REF: 8/1982/FLOOD

The following outlines our rationale and response to the Environment Agency's (EA) concerns outlined in the received letter dated 27th August 2019 (ref: HA/2019/121531/01-L01) as to why we maintain that the site is at a low risk of flooding.

Summary of the proposed development

Screenshot of flood map for planning ([Gov.uk](https://www.gov.uk))

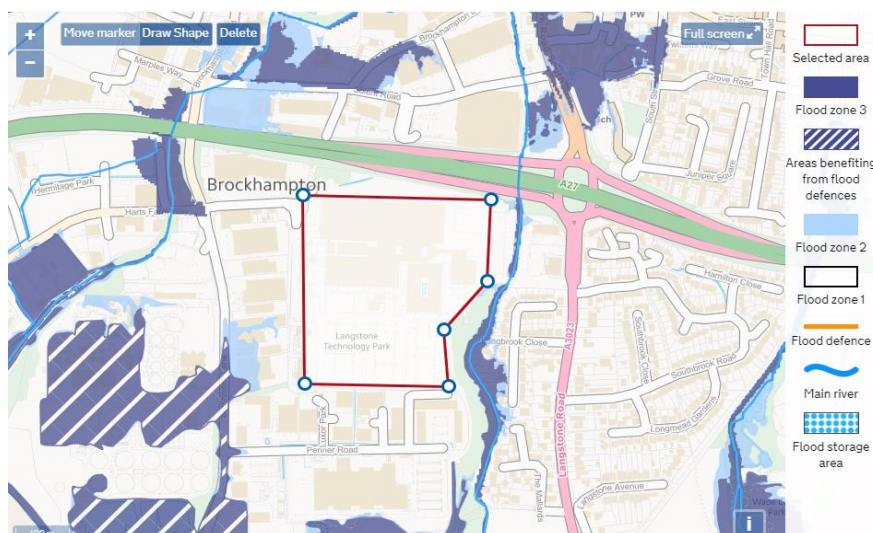
Flood mapping provided by the EA for planning indicates that the site is predominantly situated in a flood zone 1 (1 in 1000 year or smaller likelihood of flooding) The site is identified as being in flood zone 1 in the Havant local plan (2018)
